From: Palla, Robert
Sent: Thursday, October 29, 2009 1:07 PM
To: Stuyvenberg, Andrew
Cc: IPRenewal NPEmails
Subject: Weather Runs 10 29 09.doc
Attachments: Weather Runs 10 29 09.doc

Indian Point Weather

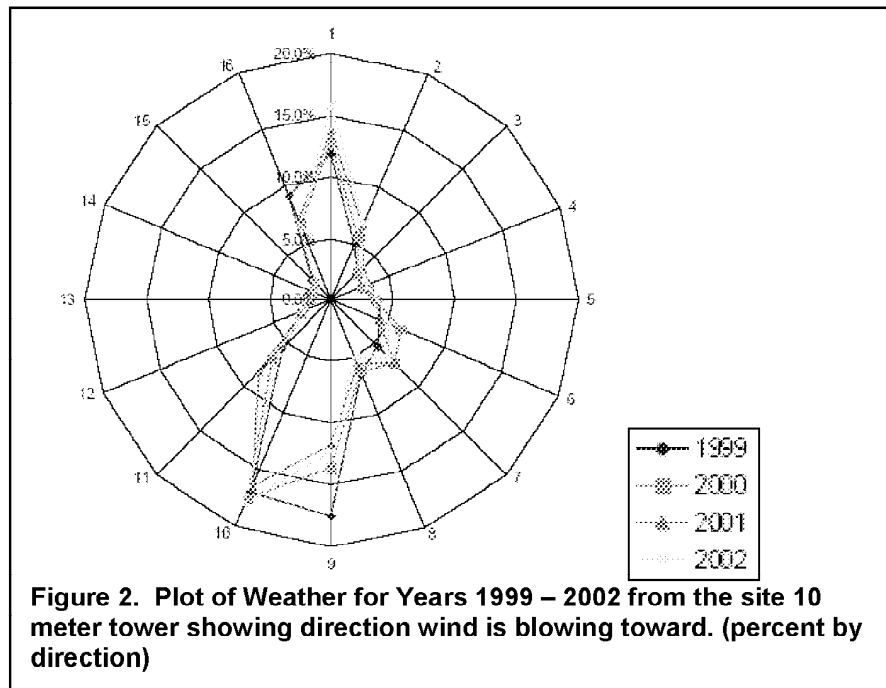
hourly weather samples (365 days x 24 hours/day) from the January 2000 to December 2004 IPEC 10 meter met tower data. The results of the averaged weather generate a wind rose

predominantly in the northerly direction as shown in Figure 1. Review of the process describing how the weather was averaged did not provide insights into why the wind rose is predominantly northerly.

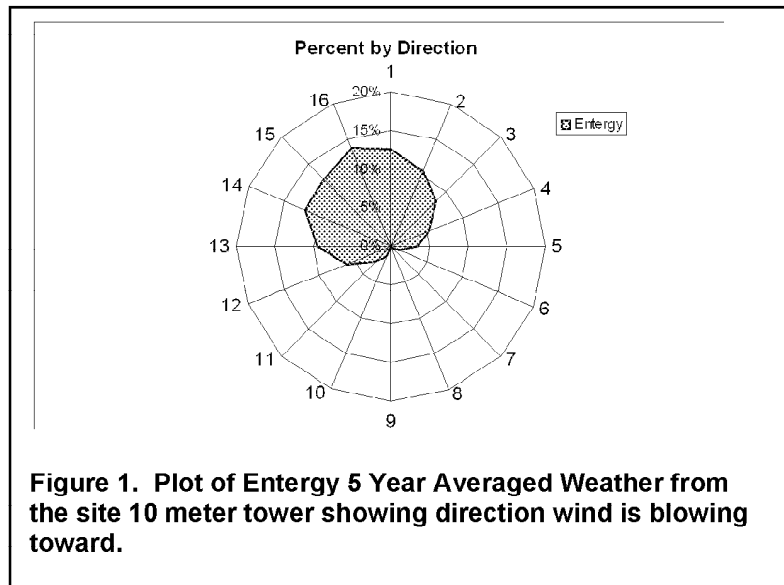
information provided in the Indian Point annual effluent reports for 1999 through 2002 (ML031220099, ML021260723, ML011240172, ML003714664), also for the 10 meter met tower. A wind rose was developed for each year from 1999 through 2002. Each of the weather files for the years 1999 thru 2002 are relatively similar, and the wind rose for each year of weather shows in Figure 2 that the northern and southern directions are

dominant. Thus, the MACCS2 input of averaged weather used in the analysis does not appear to reflect the annual weather conditions. An analysis is needed using discrete years of weather data for each or at least some of the 5 years, without averaging weather, to understand the effects of weather on the SAMA conclusions.

1. Additional information is needed in the form of consequence analyses using annual, rather than averaged, weather data. An analysis of at least one specific weather year should be conducted using the 10 meter weather information available from the site. Use of the 10 meter station may be expected to show a greater likelihood of wind in the northerly and southerly directions following the river. It may be beneficial to also perform an analysis using the weather data from the 120 meter station available from the site.
